Saxton Nuclear Experimental Corporation Facility

Decommissioning Environmental Report Revision 1

February 2000

FIGURE 7.5-1

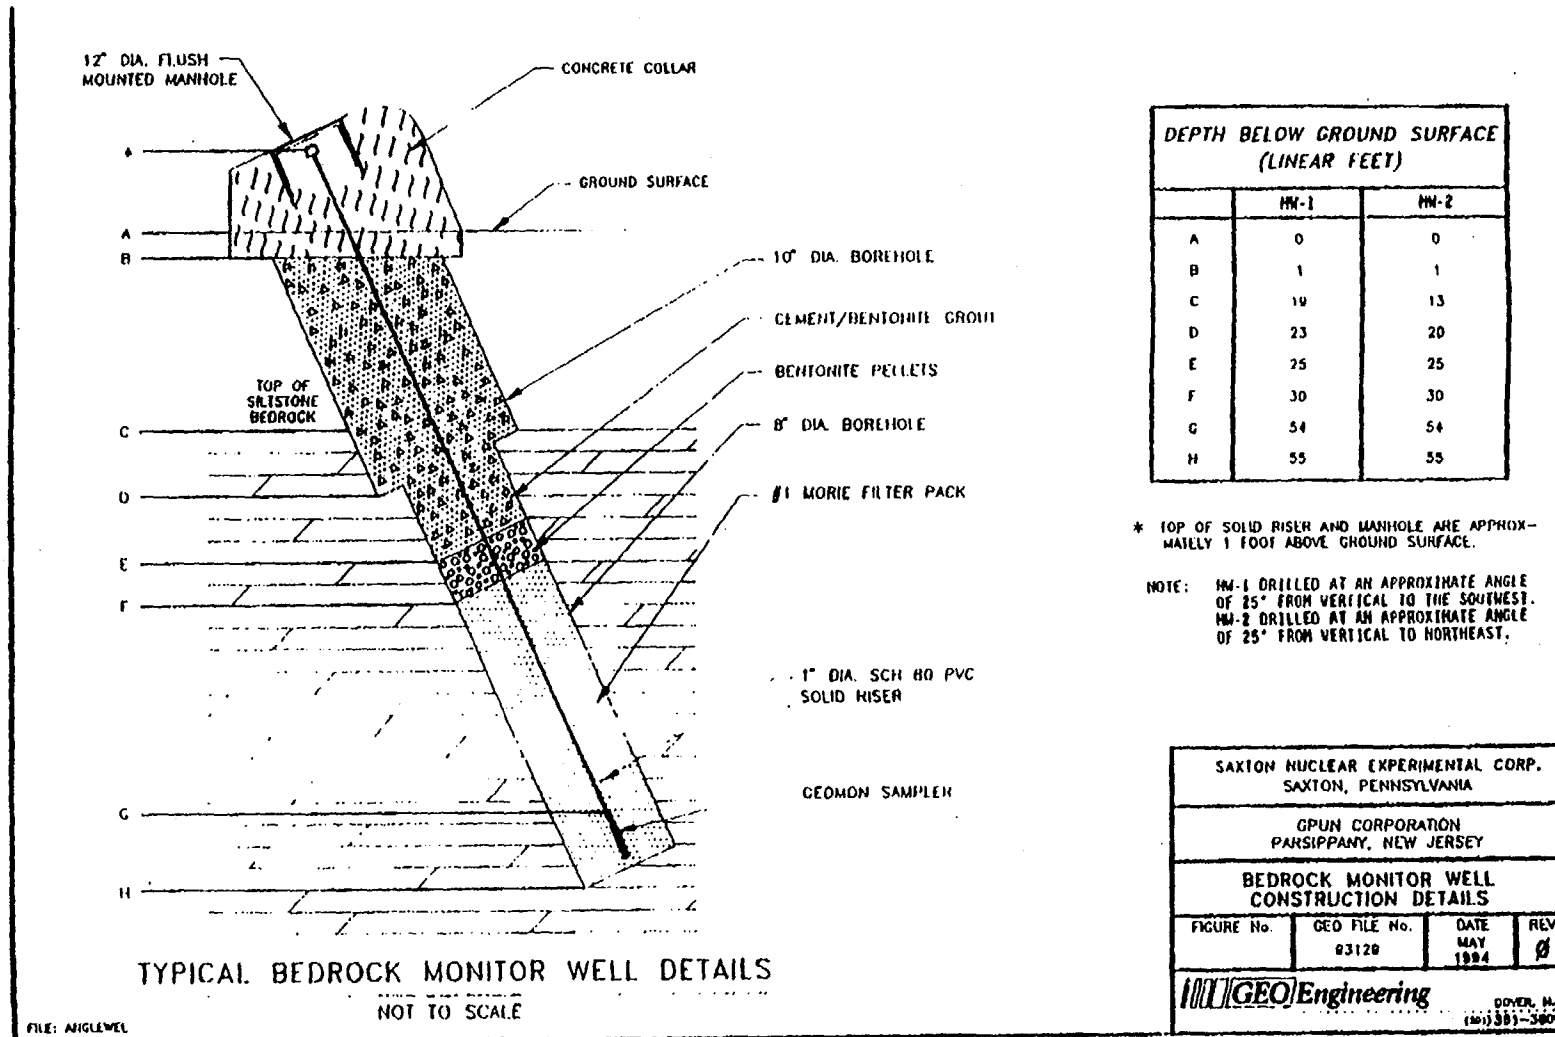
80. Page 7-6, First Paragraph - Please provide a description of the gas displacement sampler and how it is used to monitor significant fractures and bedding planes. Is there a means of isolating these zones in boreholes MW-1 and MW-2? Please describe the #1 Morie Filter Pack material in the bottom 25 feet of each borehole as depicted in Figure 7.5-1. Also, is there any use being made of groundwater from the overburden zone above bedrock in the vicinity of the SNEF?

As part of the analysis performed by the contracted hydrogeologic consultants (GEO Engineering), it was determined that bedrock monitoring wells should be installed at an angle in order to maximize the interception of fractures and bedding planes. The boreholes (MW-1 and MW-2) were drilled into bedrock at an angle of approximately 25° from the vertical to accomplish this. By sealing the annular space with grout and bentonite pellets above a depth of approximately 30 feet, fractures and bedding planes in the areas which would intercept potential outleakage from the containment vessel are monitored. Those areas are isolated in the boreholes and this is what is referred to as significant fractures and bedding planes (for monitoring purposes). Construction details can be seen on Figure 7.5-1 of the Decommissioning Environmental Report.
